Federal Emergency Management Agency

IN REPLY REFER TO:
Case No.: 93-06-332A

RE: LETTER OF MAP AMENDMENT REQUEST FOR LOT 1019, SANDIA HEIGHTS SOUTH, UNIT 10, COMMUNITY No. 350002-0011c

RE: APPEAL OF LETTER OF MAP AMENDMENT DETERMINATION FOR LOT 1019, SANDIA HEIGHTS SOUTH, UNIT 10, BERNALILLO COUNTY, NM, CASE NO. RVI-218-70-N

Drainage Management Plan

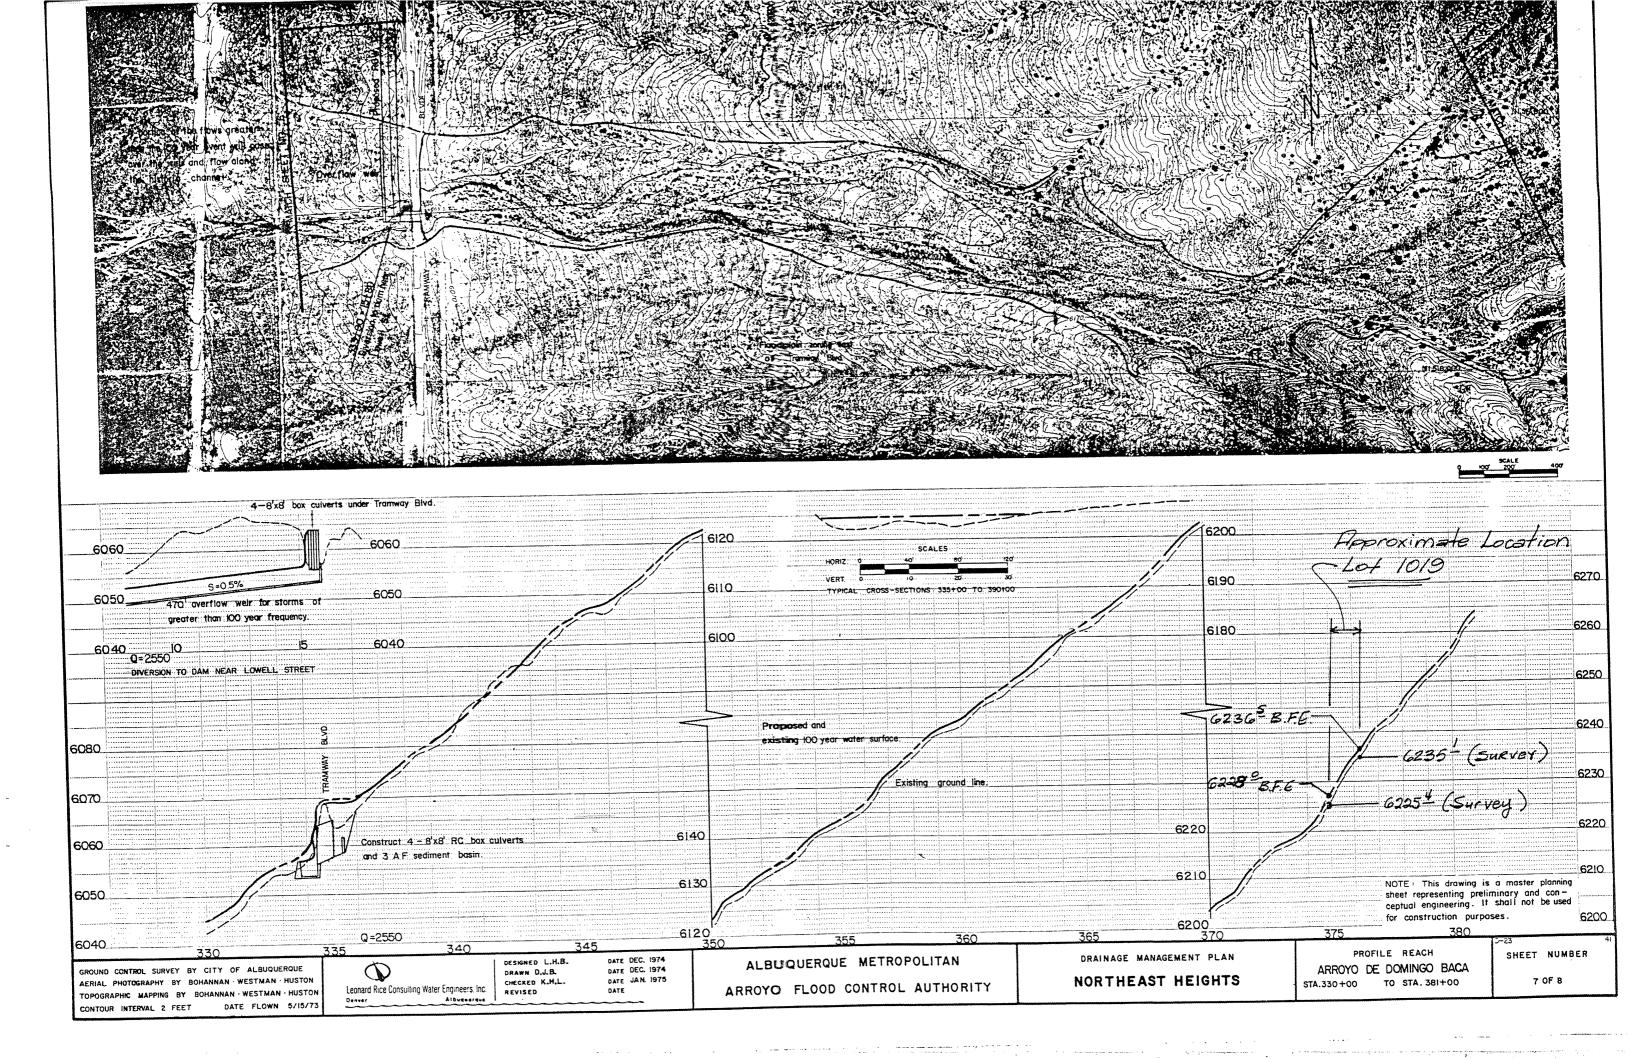
1. The Flood Insurance Study dated April 14, 1983, references a Northeast Heights Drainage Management Plan done by "Leonard Rice Consulting Engineers dated April 1975". Attached is a copy of a Flood Profile from this study for this floodplain. The base flood elevation on the upstream side of this lot is shown to be 6236.5, on the downstream side of this lot it is shown to be 6228.0. If you are to take cross sections to the floodplain and compare the water surface profile to the adjacent grade, such as a HEC-2 will compare with the right overbanks, it will show that the adjacent grades are higher than the base flood elevation.

350002 0011 C

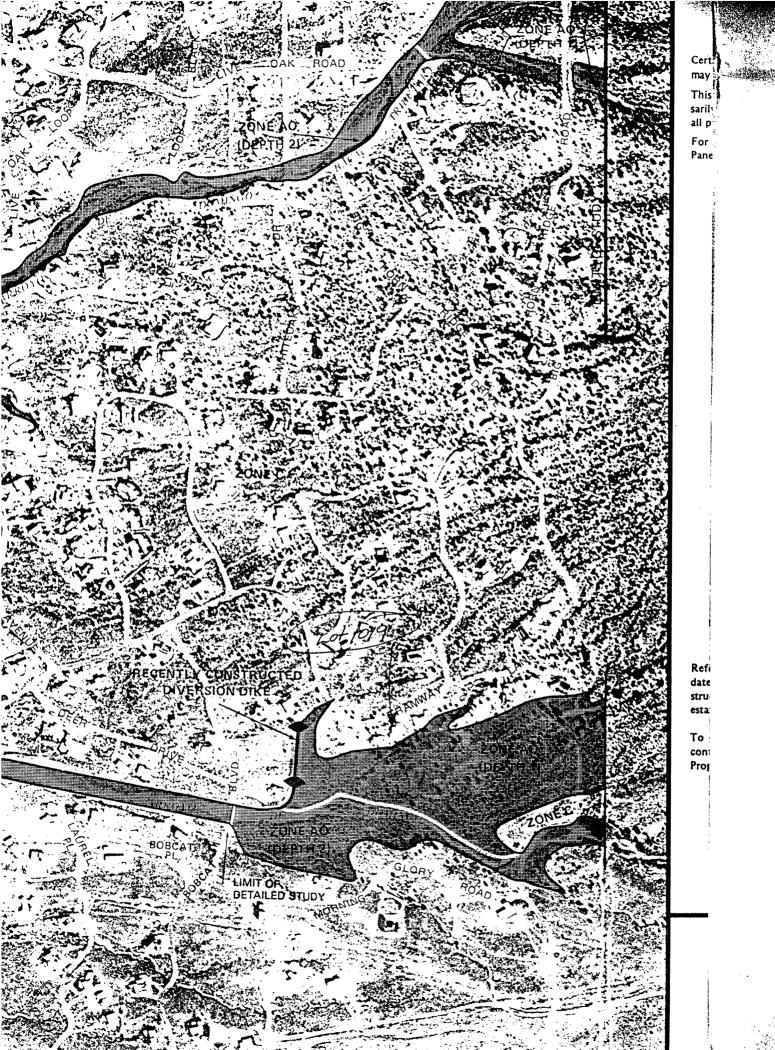
The owner of the referenced property has requested a Letter of Map Amendment. Please note that the floodzone is designated Zone AO, (Depth 1) and is shown to be confined to the arroyo south of the structure per the attached panel 350002-0011c.

Please note that the structure is not shown to be inundated by sheetflow flooding on both sides of the structure per the referenced panel; therefore, our Community feels that the following criteria recently imposed by FEMA in 1992 is not applicable in this case:

Please note that the structure is not shown to be inundated by sheetflow flooding on both sides of the structure as shown on the panel. If you look close enough the structure appears to be in floodzone "C" but clearly the property is in floodzone AO (depth 1).

After evaluating the additional information that you provided and comparing this information to the National Flood Insurance Program (NFIP) map for the City of Albuquerque, New Mexico, we determined that although portions of the property described above would be inundated by a 100-year flood, the existing structure on the property would not be inundated. This structure is correctly shown outside the SFHA on the current NFIP map and is now located in Zone C, an area of minimal flooding outside the 500-year floodplain. Because portions of the property are in the SFHA, any future construction or substantial improvement on this property remains subject to Federal, State, and local regulations for floodplain management.

TO SURVEYOR'S INSPECTION REPORT

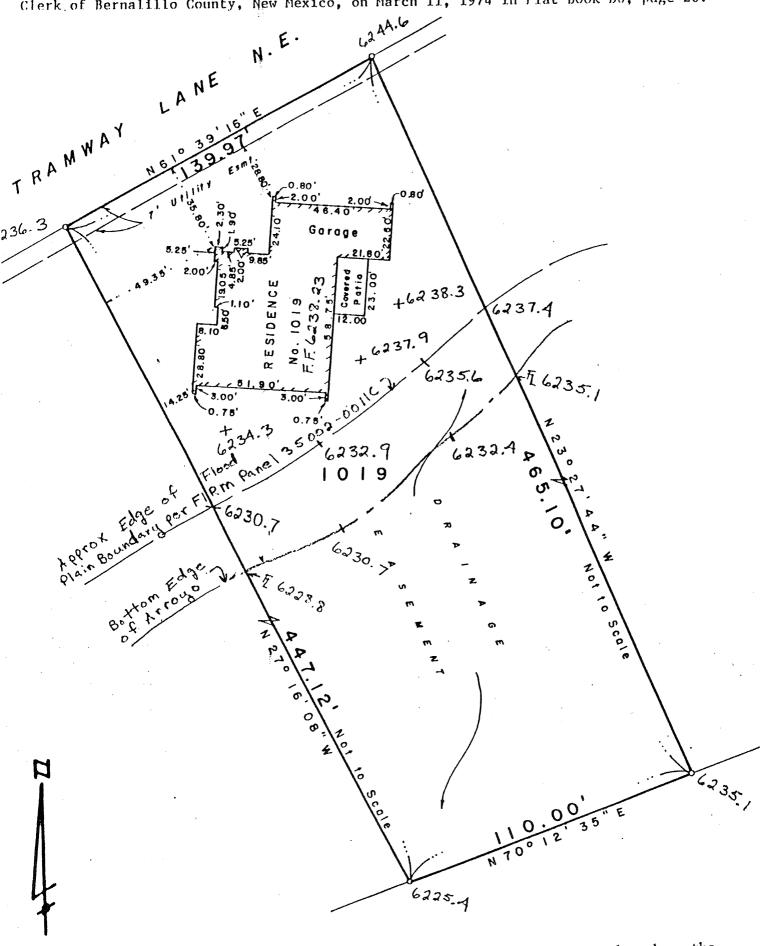
Since the elevation of the lowest adjacent grade to the structure, 6234.3*, is lower than the 100-year flood elevation, 6236.1*, the structure is within the SFHA; therefore, flood insurance is required. *These elevations are referenced to the National Geodetic Vertical Datum. This determination is based on the flood data presently available.
